## MEMORANDUM

**Subject:** Work Session – Breezeway – Pulte Homes  
10829 Fairfax Blvd; 10807-10812 Cedar Ave; 3937 Walnut St;  
3930-3934 Oak St  
Tax Map # 57 1 14 043; 57 1 14 055 A; 57 1 14 083; 57 1 14 077 A;  
57 1 14 076 A; 57 1 14 075 A

**Meeting Date:** June 11, 2018

**Figure 2: Comprehensive Plan Future Land Use Map**

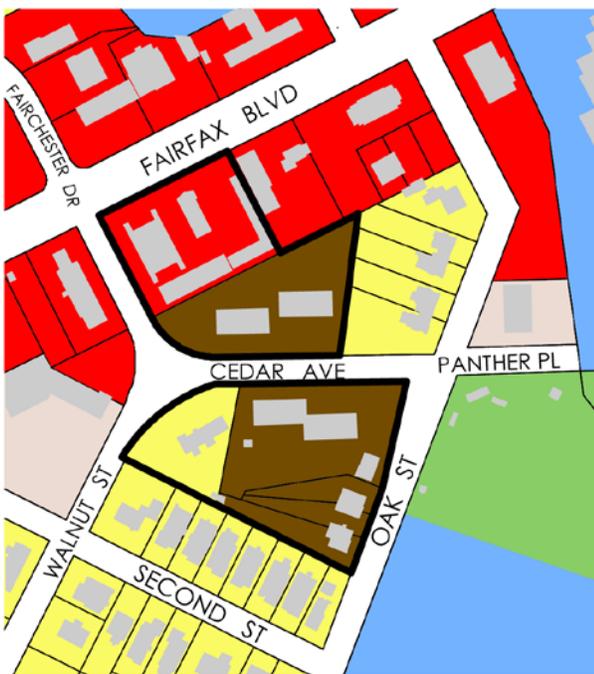
The applicant is seeking to build a residential development that abuts Fairfax Boulevard with part of the first floor commercial. The consolidated properties are overlaid on the Future Land Use Map from the Comprehensive Plan in Figure 2. This application would require an amendment to the Future Land Use Map to designate one additional of the subject properties as “Residential High” and the Breezeway Motel property as “Transitional”. The Comprehensive Plan specifically addresses this scenario as follows:

Within the area of the site proposed to be designated as Transitional, the applicant proposes residential live-work type townhouse units with commercial space on the ground floor of each unit. Commercial and residential uses are both considered appropriate uses under this land use category. The proposed commercial uses are anticipated to be small in scale as described in the above language, though the specific commercial uses that would be permitted in the units has not been clarified. The live-work townhouse units would provide limited commercial presence along Fairfax Boulevard and the Comprehensive Plan envisions the connectors as predominantly commercial uses. While the existing buildings on the site may be aging, the commercial frontage would be diminished with this proposal, replacing 19,866 square feet of hotel commercial use with 5,712 square feet of unknown commercial uses.

Residential uses in the Transitional land use category are described as “small infill single-family residential developments at densities approaching the midpoint of the medium density residential category.” This suggests a density of around 10 dwelling units per acre where an estimated 16 units per acre are proposed.

SITE LAYOUT: RT. 50 BREEZEWAY PROPERTY LOCATION: FAIRFAX CITY, VIRGINIA

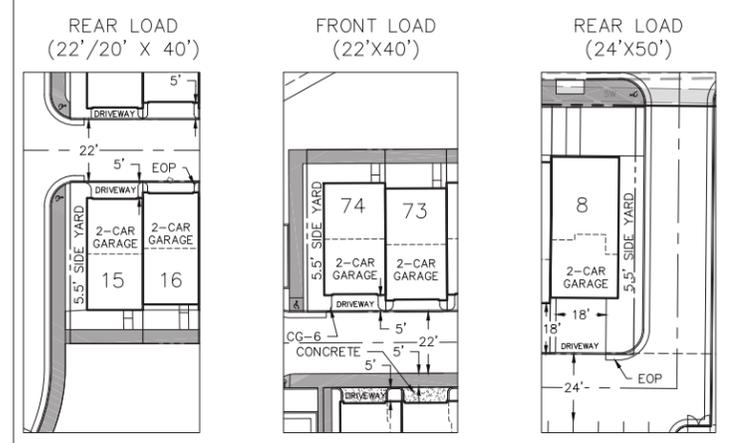
The Planned Development Mixed Use District requires at least 20 percent of the site designated as recreation and open space “for use and enjoyment of the residents and occupants of the Planned development.” The development currently proposes three areas of open space for a total of 0.73 acres or 15.7% of the property. Two of the open space areas are large areas, 0.27 acres and 0.35 acres, located immediately north and south of Cedar Avenue, accessible to both the proposed development as well as the surrounding neighborhood. The third area of 0.11 acres is located in the northeastern corner behind adjacent commercial properties. This area does not meet the zoning requirement that open spaces be a minimum of 50 feet wide. The Zoning Ordinance requires at least 60% of the required open space be contiguous, however it may be bisected by a residential street which it is in this proposal. A transitional yard buffer of 15 feet is required along all site area boundaries, which it appears this proposal is providing. Also a 10 foot landscape strip is shown along all public rights of way.

The applicant proposes three entrance/exit access points into the northern section of the site from Fairfax Boulevard, Walnut Street and Cedar Avenue and only one entrance/exit for the southern section onto Cedar Avenue. Staff questions the need for three access points for the northern section.

Parking: The applicant’s parking tabulations give the impression of an overabundance of parking compared to what is required; however, on street parking on a City road may not be included in parking calculations for the development.

The applicant’s parking tabulations use 1 space per 300 square feet for the commercial uses. Without knowing what uses are proposed in the live-work units at this time, the best course of action would be to use the 1 space per 200 square feet requirement which includes uses such as medical offices, general retail, general and personal services which are possible tenants of those spaces. Using the 1/200 calculation, the required parking for the commercial component is 29 spaces. The applicant’s parking table refers to the garage and driveway spaces for those units as the designated parking for the commercial uses. It is far more likely that the garage spaces would be utilized for the upper living quarters and the nearby surface parking be used by customers for the businesses. There are 16 spaces in the driveways for the live-work units and 16 surface spaces immediately adjacent to those units for a total of 32 spaces which exceeds the 1/200 requirement of 29 spaces.

Bicycle parking and storage facilities are required for all non-residential uses. This proposal would require 2 bicycle parking spaces. The plan does not show any proposed bicycle parking for the commercial uses at this time although there appears to be adequate space on site to incorporate it.

The applicant is proposing a sidewalk network throughout the site that connects the surface parking to the units and existing sidewalks along the adjacent roadways. However, staff is concerned about the pedestrian circulation for the customers for the live-work units. There is no sidewalk along the access road from Fairfax Boulevard. With no break between the 8 units, it is unlikely that a visitor to the end units close to the access drive will choose the only safe option provided to walk to Walnut Street and around the corner to the fronts of those units on Fairfax Boulevard. A break between units 4 and 5 with a pedestrian walkway leading from Fairfax Boulevard to the rear parking or a walkway along the access drive would provide a safer and more convenient alternative than walking in the access drive.
